# Access Compliance Report

## Public Rights-of-Way

### (Curb Ramps)

Intersection ID: 11981	Main Street: W_6TH_ST	Cross Street: N_CHURCH_ST	Location: N
ADA ID: E0AE3AF8293E	Ramp Type: BlendTrans1	Initial Pass/Fail: Fail	Overall Compliance: No
Severity Score: 21.25			
Codes/Mitigation Info/Possible Solution		Field Measurements/Component Compliance

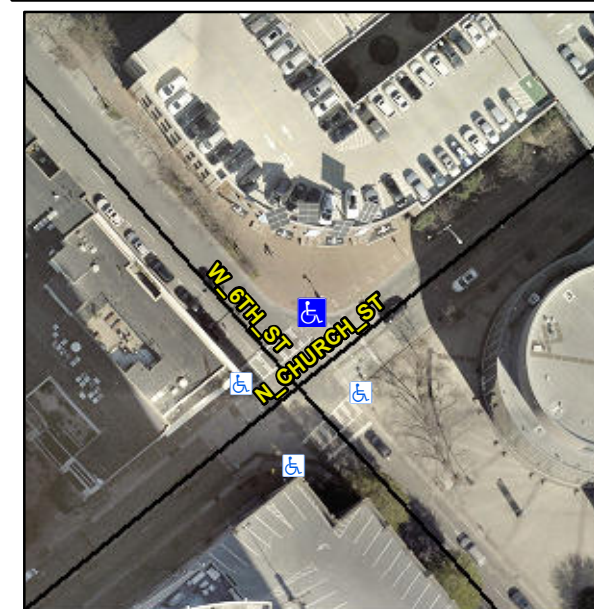
**Not Found, R304.5.1, R304.5.3**

Compliance	Description	Data	Compliance	Description	Data
N/A	Ramp Length (in)	82.0	Yes	BlendTrans Slope (%)	4.6
No	Ramp Width (in)	40.0	No	BlendTrans XSlope (%)	5.5
N/A	Flare Type LT	N/A	N/A	Flare Type RT	N/A
N/A	Flare Slope LT (%)	N/A	N/A	Flare Slope RT (%)	N/A
N/A	Flare Traversable LT?	N/A	N/A	Flare Traversable RT?	N/A
N/A	Landing Length (in)	N/A	N/A	DWS Provided?	N/A
N/A	Landing Width (in)	N/A	N/A	DWS Contrast?	N/A
N/A	Landing Slope (%)	N/A	N/A	DWS Length (in)	N/A
N/A	Landing X Slope (%)	N/A	N/A	DWS Full Width?	N/A
N/A	Landing Curb? (Y/N)	N/A	N/A	DWS Offset (in)	N/A
N/A	Shared Landing?	N/A			
N/A	Gutter Ponding?	N/A	N/A	Gutter Slope (%)	N/A
N/A	Gutter Lip Ht (in)	N/A	N/A	Gutter X Slope (%)	N/A
N/A	Painted X Walk1?	Yes	N/A	Painted X Walk2?	Yes
	X Walk 1 Direction	To SW		X Walk 2 Direction	To SE
	X Walk 1 Width (in)	123.0		X Walk 2 Width (in)	117.0
	X Walk 1 Slope (%)	0.9		X Walk 2 Slope (%)	1.8
	X Walk 1 X Slope (%)	0.0		X Walk 2 X Slope (%)	0.7

N/A	Ramp inside XWalk1?	Yes	N/A	Ramp inside XWalk2?	Yes
	Road Slope (%)	4.0		Clear Space?	N/A
	Road X Slope (%)	1.7	N/A	Clear Space to XWalk (in)	N/A
N/A	Any Obstructions?	N/A	N/A	Storm Grate/Utility Hazard?	N/A
	Obstruction Type			Storm Grate/Utility Type	
		N/A			N/A
		Yes		Surface Condition? (G/P)	Good
		No		Curb Slope (%)	5.3

**Remove & Replace Curb Ramp With Two New Directional Ramps or Equivalent.**
